AMENDMENTS TO THE DRAWINGS:

REMARKS

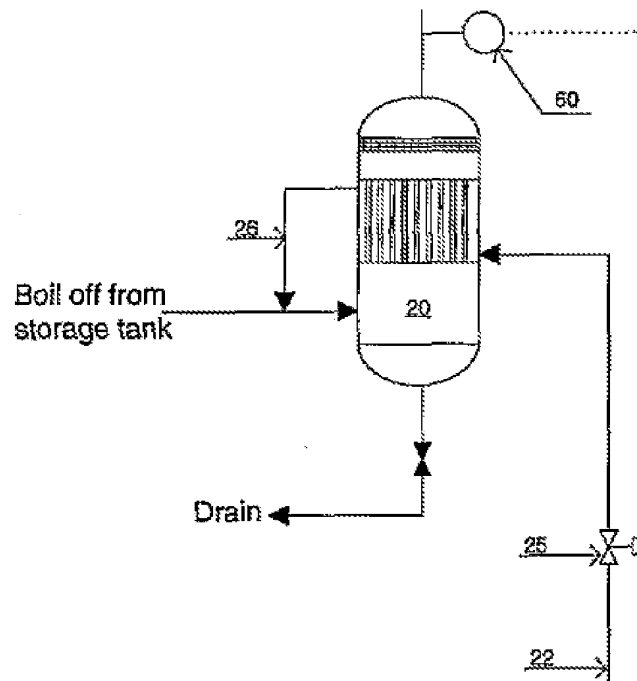
The Official Action rejected claims 2 and 8 under 35 USC 112, second paragraph as being indefinite.

As to claim 2, the Official Action alleges that it is unclear how mixing of evaporated LNG with boil-off gas occurs upstream of the heat exchange.

As to claim 8, the Official Action alleges that it is unclear how the combined mist separator and head exchanger can be connected to the feed line upstream from itself.

In reply, claims 2 and 8 are amended as indicated above to clarify the recited features. It is further respectfully submitted that a mixing of fully evaporated LNG with boil-off gas upstream of the heat exchange, as recited by claims 2 and 8, is adequately disclosed by the specification and the drawing figures as originally filed such that one of skill can readily comprehend the make the invention.

For example, Figure 2 (detailed above for the Examiner's convenience) discloses a "second conduit 26 fluidly connects the heat exchanger 20 to the boil-off gas feed line at a point upstream of the heat exchanger 20," (page 5, lines 14-15), wherein the heat exchanger is connected at its other side to the line carrying LNG from the cold box 30 to the storage tank (page 5, line 1 and lines 11-14). The arrowed line extending from the legend "Boil off from storage tank" clearly indicates the boil-off gas feed line with a direction toward the combined mist separator and heat exchanger 20. The second conduit 26 meets the boil-off gas feed line at a point prior to the intersection with the combined mist separator and heat exchanger 20.

Hence, LNG fully evaporated by the combined mist separator and heat exchanger 20 mixes with the boil-off gas at a

location upstream of said boil-off gas entering the combined mist separator and heat exchanger 20.
